Re: Indian Point Unit No. 2
Docket No. 50-247

The Enclosure to this letter provides additional information requested during discussions with members of your staff on October 11, 1985 regarding the removal of the Boron Injection Tank (BIT) at Indian Point Unit No. 2.

Supporting Information Regarding Boron Injection Tank
Removal at IP-2

Containment Capability Study Pressure vs Steam-Air Internal Energy

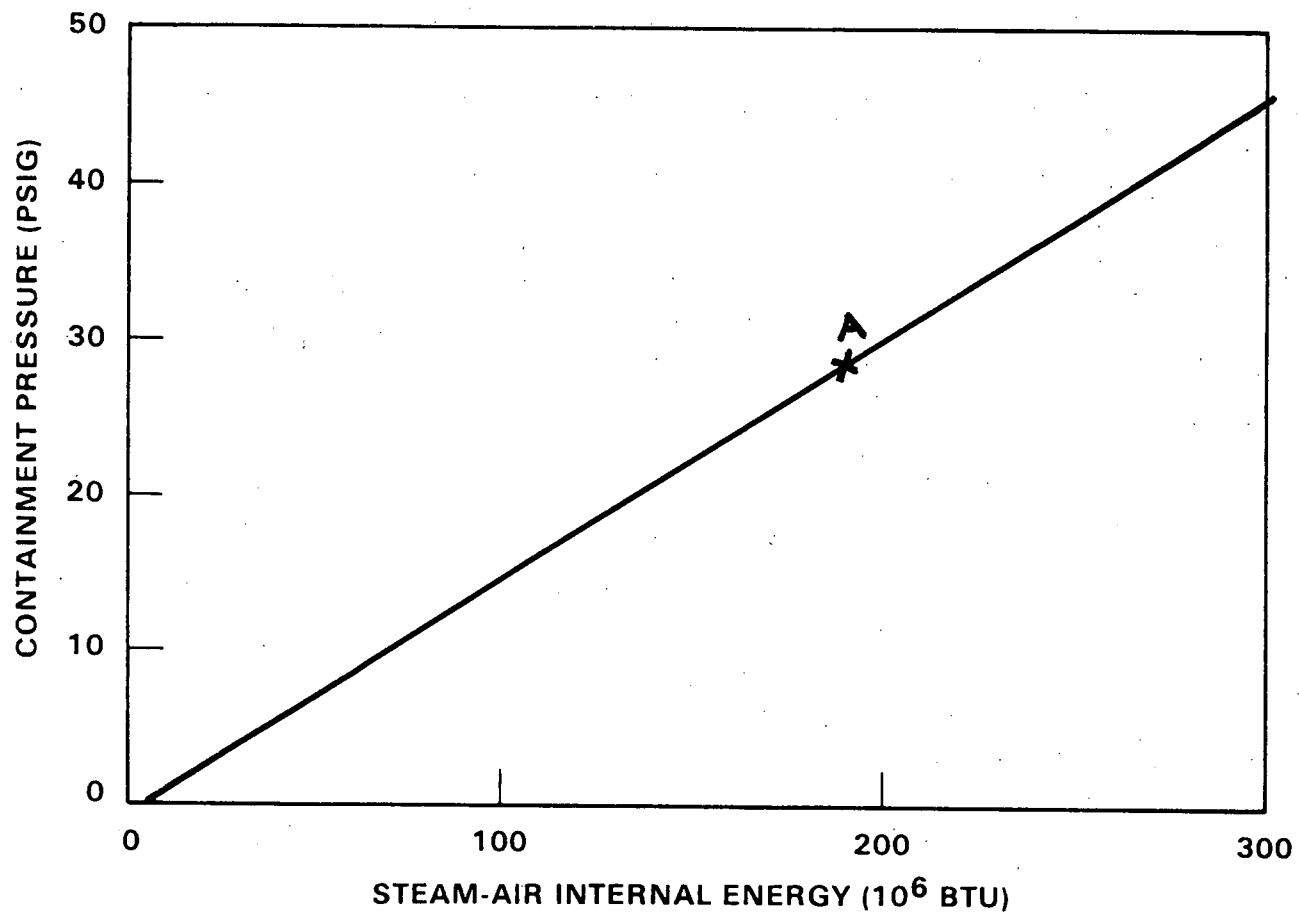
The purpose of this response is to provide additional information regarding the derivation/use of the FSAR containment pressure/energy curve and the basis for its conservatism.

The 43 psig is only reported in our August 2, 1985 submittal to be consistent with the original FSAR methodology and to show margin in the containment design. Hypothetically, assuming an instantaneous release to the containment and also taking no credit for containment safeguards and heat sink of the containment structures, the containment pressure was calculated to be 43 psig (per FSAR Figure 14.3-107), compared to the containment design value of 47 psig.

FSAR Figure 14.3-107 was derived by Westinghouse as part of the original licensing basis of IP-2 based on the methodology shown in Attachment 1. This figure was used for the original FSAR main steam line break analysis as follows. For the mass energy release of 182×10^6 BTUs in the original FSAR analysis a containment pressure of 27 psig was calculated and is shown as Point A in Attachment 1. The containment pressure calculated from the pressure/energy relationship from FSAR Figure 14.3-107 is conservative because it does not take into account the containment structural heat sinks or active heat removal capability. Thus Attachment 1 shows the energy absorption capability of the $2.6 \times 10^6 \text{ft}^3$ free volume of the IP-2 containment at saturated conditions regardless of the mechanism, i.e., LOCA or Steam line break.

The pressure/energy curve is derived by calculating the total energy for various total pressures. Since total pressure equals air pressure plus steam pressure we assume various steam pressures and calculate the corresponding air pressure. We then iterate on steam pressure until the sum of steam and air pressures equals the total pressure. The example case shown here is at the last iteration.

Calculate the total energy for an assumed total pressure that equals containment design pressure of Indian Point Unit No. 2 (47 psig)

Or $P_{\text{total}} = 42.8 + 18.9 = 61.7$ which is equal to the containment total pressure and thus no further iteration is required.

$$= 306 \times 10^6 \text{ BTU}$$
